RS-21-045

LaSalle County Station, Units 1 and 2
Renewed Facility Operating License Nos. NPF-11 and NPF-18
NRC Docket Nos. 50-373 and 50-374

Subject: Response to Request For Additional Information (RAI) Regarding Request For License Amendment Regarding Ultimate Heat Sink (EPID-L-2020-LLA-0165)

Figure 7 from Reference 1

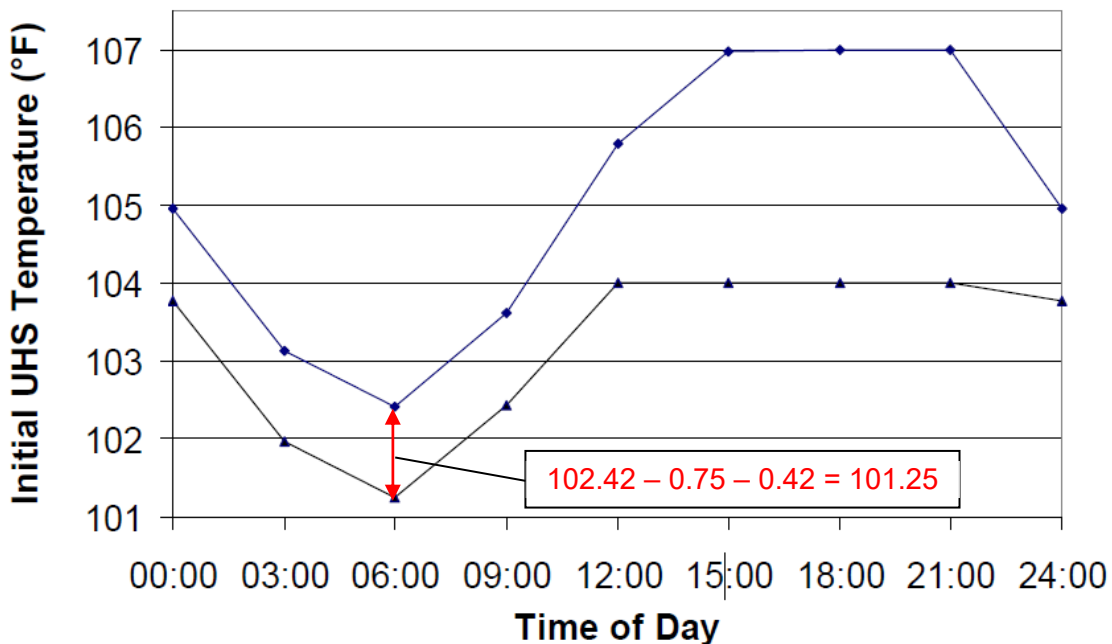
Provide the technical basis for the proposed values used to calculate the limits for the peak initial UHS temperature. Specifically, discuss how the reduction in "additional margin" used to calculate the peak initial UHS temperature is sufficient to ensure the maximum temperatures do not exceed the safety analysis limit and justify the reduction of margin from 0.42°F to 0.25°F.

The current 0.42°F of additional margin was added to reference the most limiting initial UHS temperature in the existing diurnal curve to the previous Technical Specification 3.7.3, " Ultimate Heat Sink," temperature limit of 101.25°F as described in Reference 1.

The results of analyses performed at worst case synthetic weather conditions identified the maximum initial water temperatures that would result in a peak UHS water temperature of 107°F. The most restrictive initial temperature for silt levels at 18 inches was 102.42°F starting at 06:00 in the morning. This temperature value was referenced to the past Technical Specifications (TS) peak lake temperature limit of 101.25°F which was in effect prior to approval

of the existing diurnal curve implemented through Reference 2. Instrument uncertainty for the Circulating Water (CW) inlet temperature instruments is 0.75°F.

Therefore, Additional Margin = $102.42 - 101.25 - 0.75 = 0.42^{\circ}\text{F}$.

The additional discretionary margin of 0.42°F, while not required, was included to provide added conservatism to the overall temperature limitations of the diurnal curve. The value of 0.42°F was subtracted from the most limiting initial UHS temperature after the analysis was performed for the determination of the peak initial temperatures which would result in a maximum UHS temperature of 107°F. An operationally convenient discretionary 0.25°F adjustment factor, or margin, was used in generating the proposed TS Figure 3.7.3-1 in Reference 3 for the 6 inch siltation level to ensure that the peak initial UHS temperature does not exceed 106°F which is the highest evaluated temperature for non-safety related systems.

For this reason, the change in the additional margin of 0.42°F to 0.25°F will not impact the results of the original analysis. The current instrument uncertainty provides sufficient margin to conservatively monitor UHS temperature without the risk of inadvertently exceeding the maximum UHS temperature of 107°F.
